MERCED VISION 2030 GENERAL PLAN

Proposed Changes Since August 2010 Public Review Draft

(*Revised--9/1/2011)

EXHIBIT 1

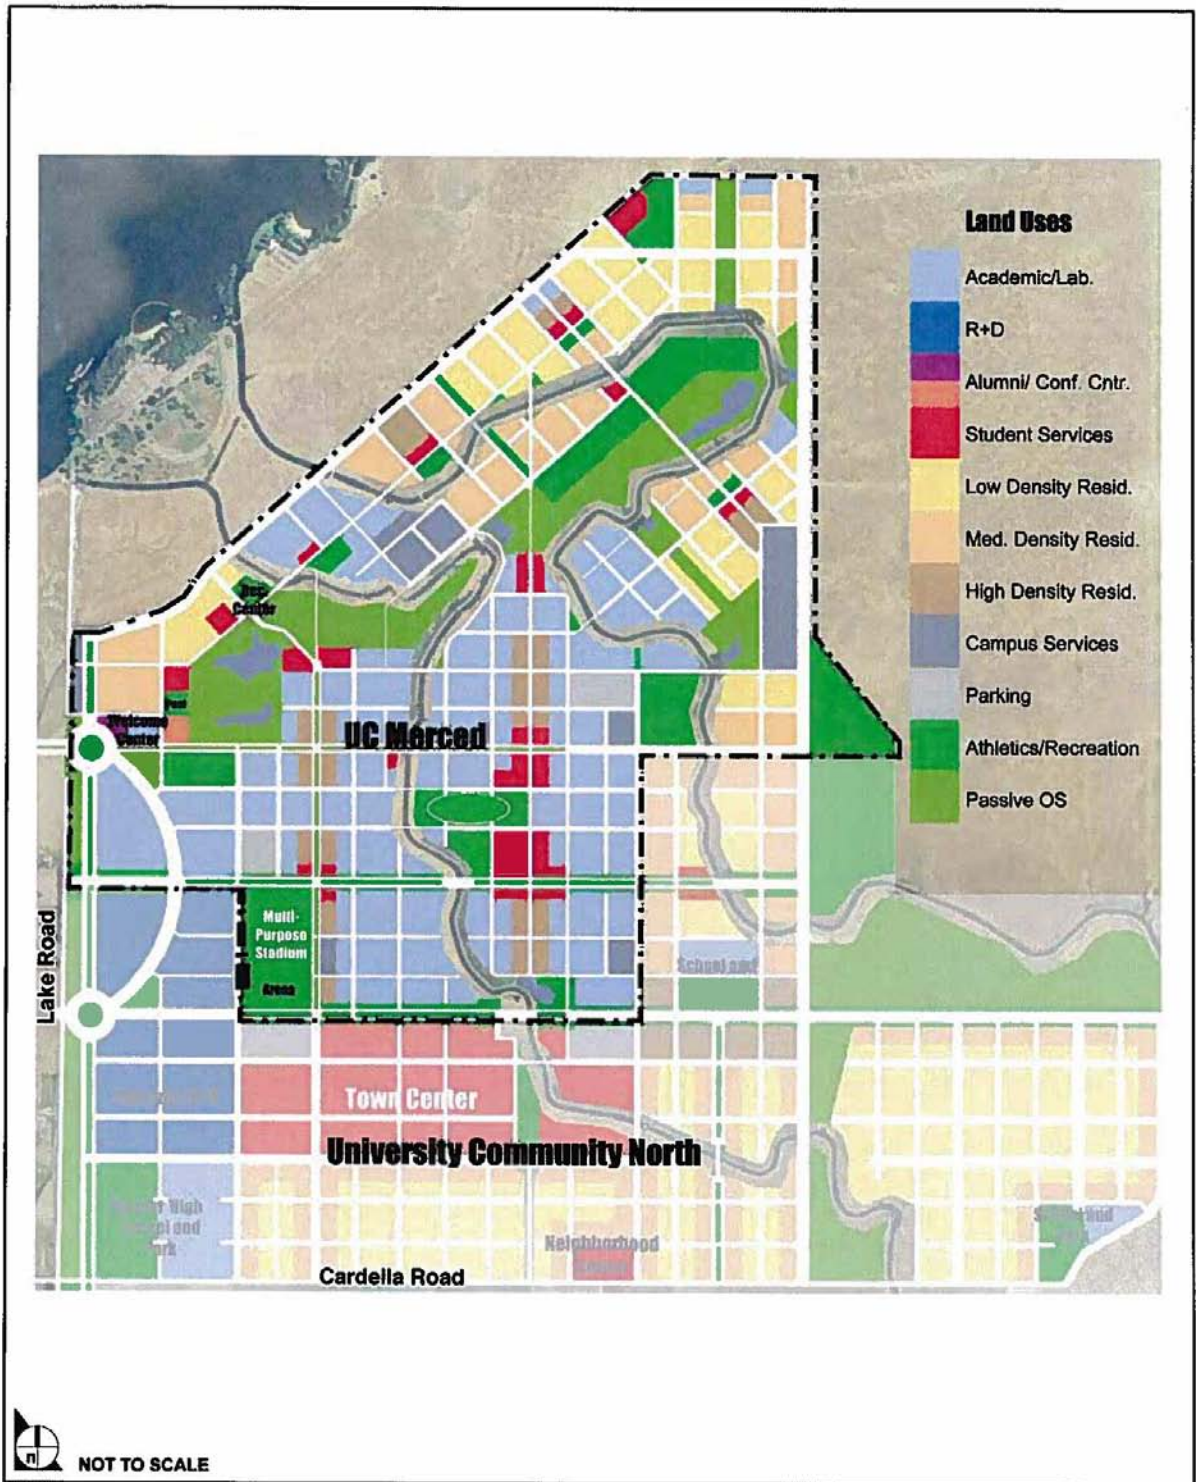
#	Pg.	¶	Col.	Change	Source
1	--	--	--	Various Figures, Maps, and Table throughout the General Plan document will be modified to reflect the 2009 UC Merced and University Community North boundaries as adopted by the UC Board of Regents in 2009. This will include changes to the Land Use Diagram and SUDP/SOI boundary for those areas only. See Exhibit 1 for the 2009 UC/UCP boundaries.	CS/UC

Figure 4.27f
Yosemite Avenue (East of Parsons/Gardner) Special Section

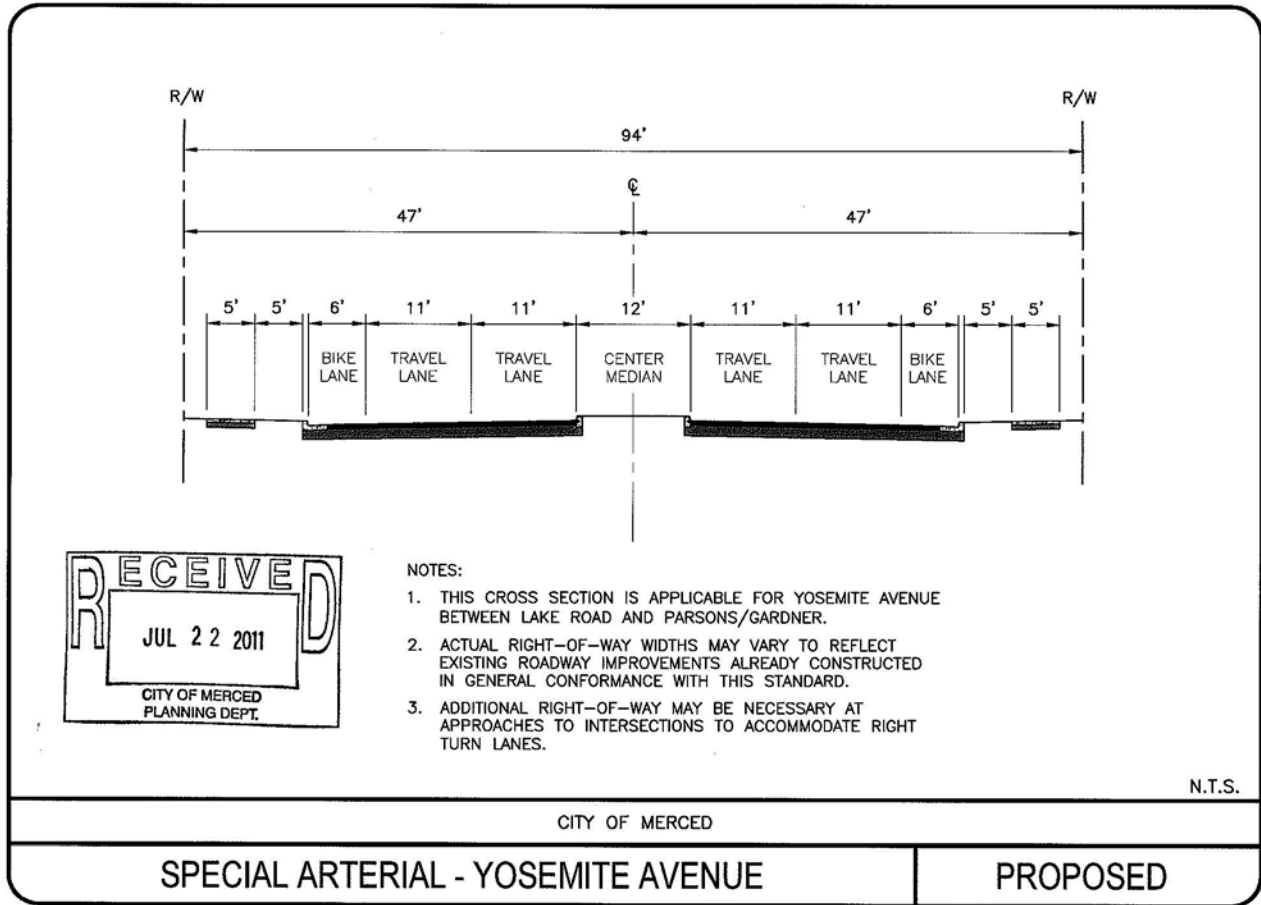
#	Pg.	¶	Col.	Change	Source
43	4-5	--	--	Figure 4.1-Circulation Plan should be modified to remove Kibby Road as a collector between Childs & Gerard per General Plan Amendment #06-01, approved on Sept. 28, 2009, and to change the designation for Yosemite Avenue, east of Parsons/Gardner to a "Special Arterial" with a right-of-way of 94 feet and a cross section as shown in added Figure 4.27f (see Item #60 below).	CS/CL
44	4-7	2	L	1 st sentence should read: "It will be extremely important for the City to continue to work closely with Caltrans, the County, and MCAG in the future regarding several important regional circulation issues which are discussed in more detail later in this chapter:"	CS
45	4-22	3	R	Last sentence should read: "Construction efforts are anticipated to begin by as early as 2011 <u>within the next few years.</u> "	CS
46	4-26	1	L	The 3 rd sentence should read: "Details of the existing and planned system are presented in the Merced Bicycle Plan, adopted in 2008 (Figure 4.9), <u>an implementing action of the General Plan, which is updated every four years. The alignments shown are conceptual and subject to further refinement prior to actual construction.</u> "	BAC/ CL

- NOTES:
1. THIS CROSS SECTION IS APPLICABLE FOR YOSEMITE AVENUE BETWEEN LAKE ROAD AND PARSONS/GARDNER.
 2. ACTUAL RIGHT-OF-WAY WIDTHS MAY VARY TO REFLECT EXISTING ROADWAY IMPROVEMENTS ALREADY CONSTRUCTED IN GENERAL CONFORMANCE WITH THIS STANDARD.
 3. ADDITIONAL RIGHT-OF-WAY MAY BE NECESSARY AT APPROACHES TO INTERSECTIONS TO ACCOMMODATE RIGHT TURN LANES.
